# Work Order ID 86963

<b>DART AEROSPACE LTD</b>		<b>Work Order:</b>	86963
<b>Description:</b> Head Rest		<b>Part Number:</b>	D3303-3
<b>Inspection Dwg:</b> D3303	<b>Rev:</b> B	<b>Page 1 of 1</b>

DESIGN <i>[Signature]</i>	DRAWN BY <i>[Signature]</i>	<b>DART AEROSPACE LTD</b> HAWKESBURY, ONTARIO, CANADA	
CHECKED <i>PH</i>	APPROVED <i>[Signature]</i>	DRAWING NO. <b>D3303</b>	REV. B SHEET 1 OF 4
DATE <b>06.08.17</b>	TITLE <b>HEAD REST</b> SCALE 1:3		
REV A	DATE 04.08.18	DESCRIPTION NEW ISSUE	
B	06.08.17	UPDATED FLAT PATTERN TO FORM PART IN ONE OPERATION USING OFFSET DIE

DRAWING NO. D3303	TITLE HEAD REST	REV. B	DART AEROSPACE LTD ENGINEERING ORDER		D.E.O. NO. D3303-B-1	SHEET NO. SHEET 1 OF 1	SCALE NTS
DRAWN AJS	CHECKED L	MFG. APPR. M	APPROVED MAD		DE APPR. H		
DATE 08.10.15	DATE 08.10.15	DATE 08/10/16	DATE 08/10/16		DATE 08/10/16

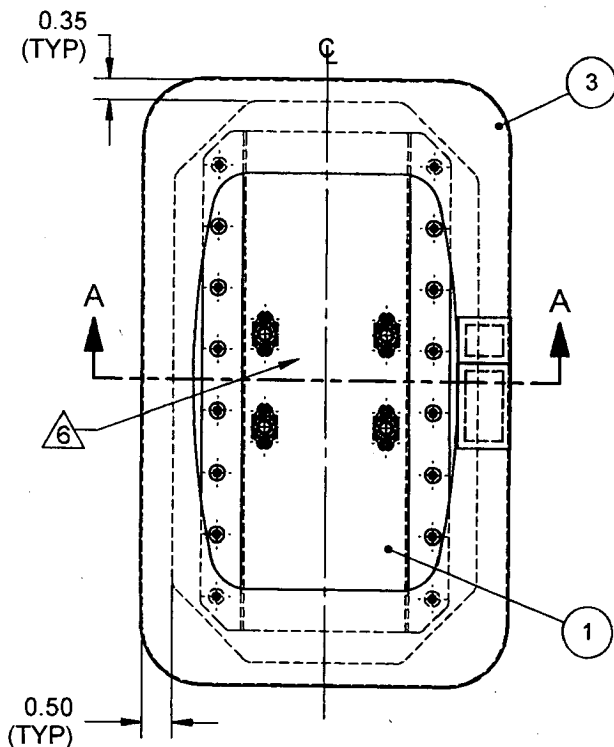
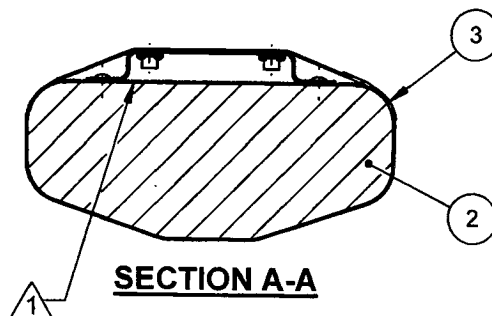
SHEET 1 ADD 1300L ADHESIVE BY 3M TO NOTE 1 AS FOLLOWS:

WAS:

NOTES:

- 1) BOND D3305-1 FOAM TO D3303-043 BRACKET ASSEMBLY USING 3M 1300 ADHESIVE (0.002" TO 0.010" THICK) IN ACCORDANCE WITH MANUFACTURER'S INSTRUCTIONS

IS:

NOTES:

- 1) BOND D3305-1 FOAM TO D3303-043 BRACKET ASSEMBLY USING 3M 1300 OR 1300L ADHESIVE (0.002" TO 0.010" THICK) IN ACCORDANCE WITH MANUFACTURER'S INSTRUCTIONS
